20006
Blackglen Road, Lamb's Cross
Sandyford, Dublin 18
August 22nd 2022

E: Response to ABP + DLRCC Opinion

Proposed Residential Development at Blackglen Road

Strategic Housing Development

2 Proposed Site Section

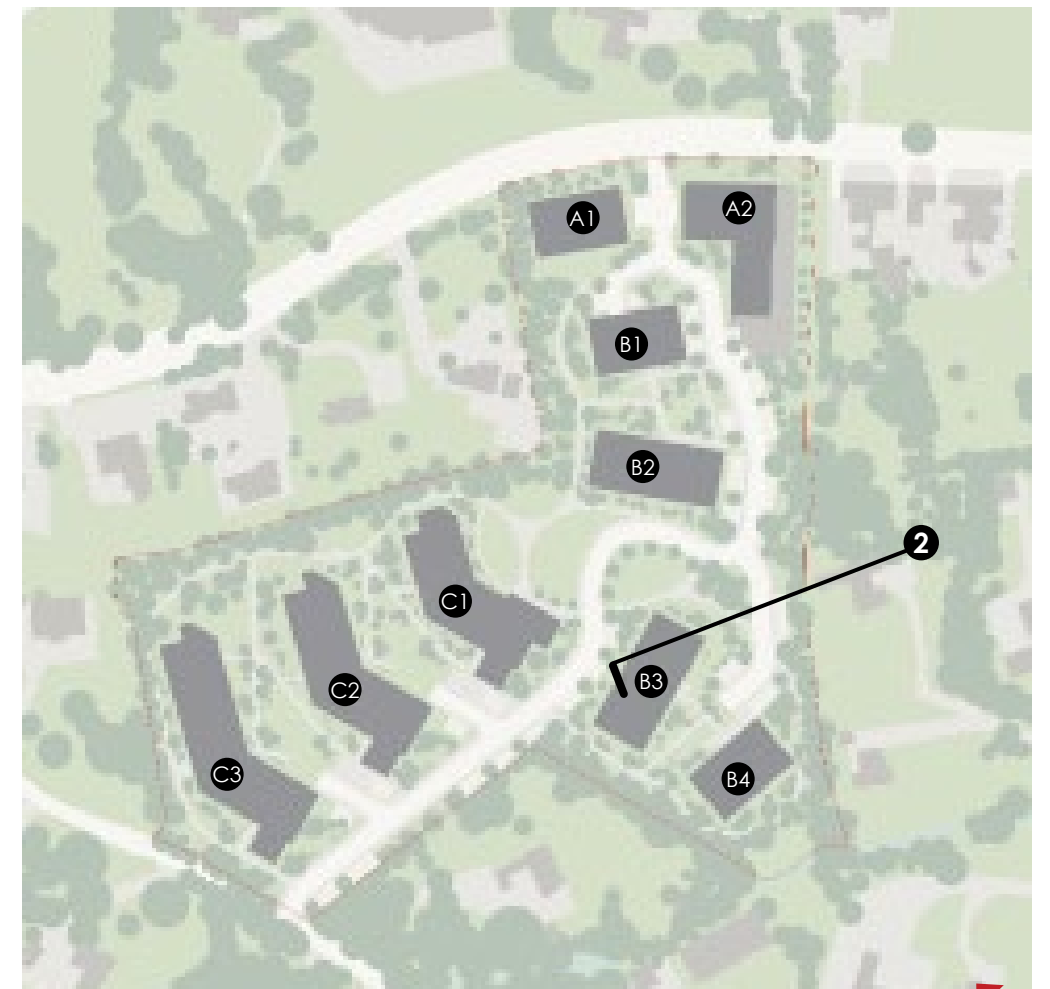
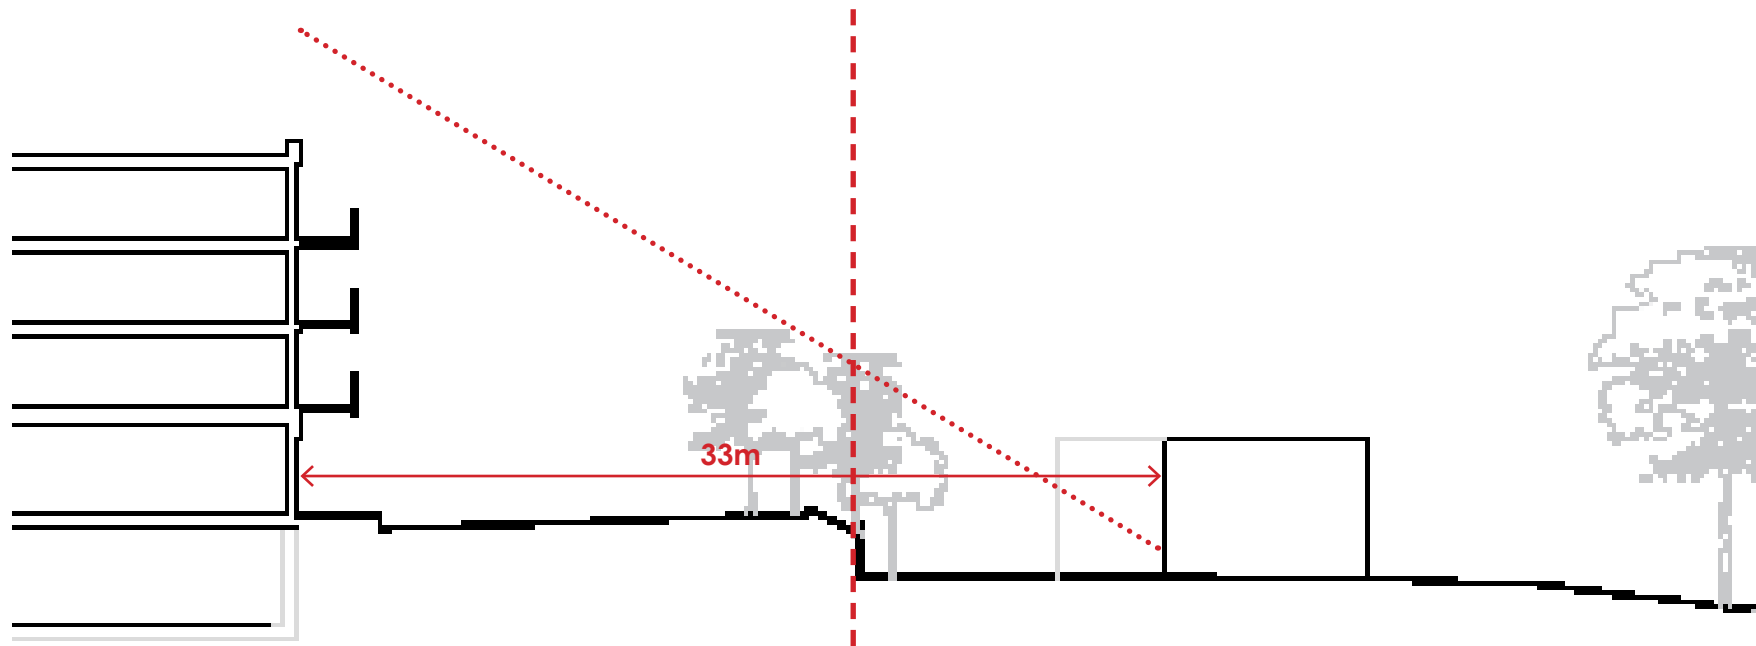
8. A report that addresses issues of residential amenity (both existing residents of adjoining development and future occupants), specifically with regards to potential overlooking, overshadowing and and overbearing. The report shall include full and complete drawings including levels and cross-sections showing the relationship between the proposed development and adjacent residential development, and comprehensive Daylight and Shadow Impact Assessment.

The separation distances between the proposed development and the surrounding Blackglen Road properties to the East are 40m.

In addition to the considerable setback distance provided along the Northern boundary, the visual impact of the proposal is reduced with the three storey shoulder height facing East towards the neighbouring property.

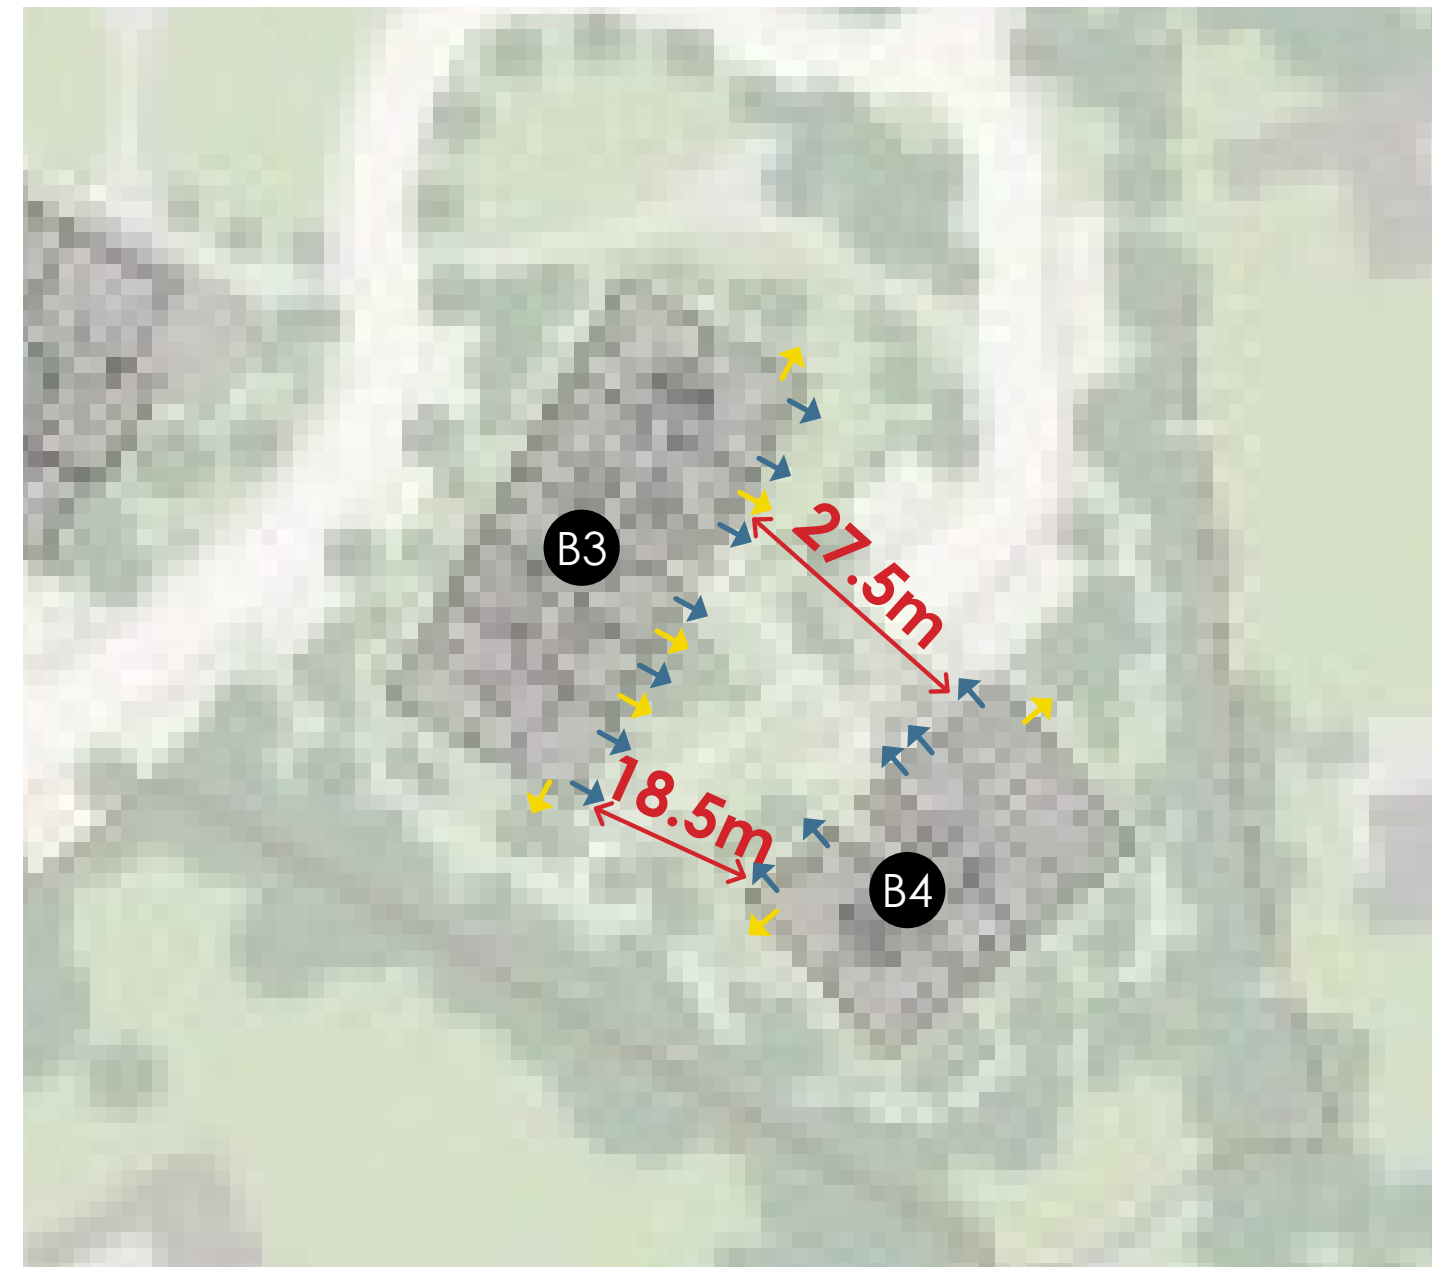
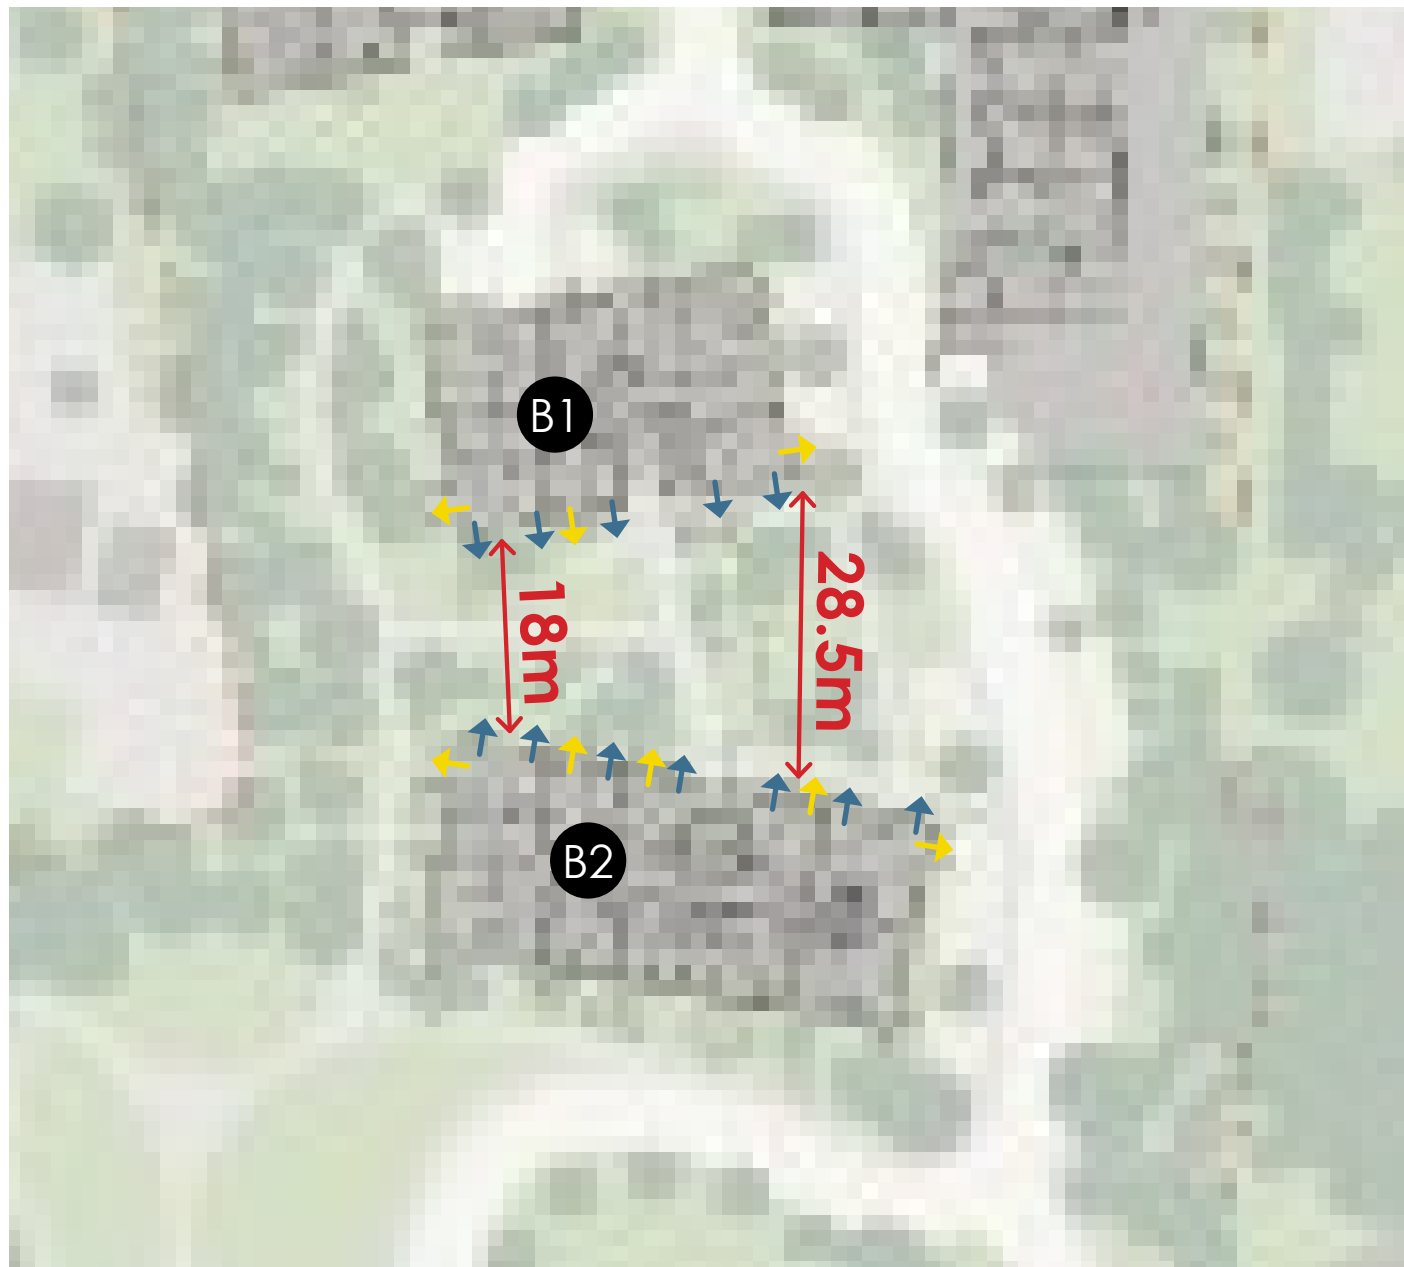
6. A full arboricultural impact assessment should be provided detailing impacts and protection measures to existing vegetation.
7. The Applicant is advised to explore design solutions to address the concerns of the Planning Authority in terms of potential overlooking between Blocks B3 and B4.

We refer to the amended scheme design and the adjustment to the buildings disposition and orientation. The widening of the angle between the buildings and increased separation distance between opposing windows.
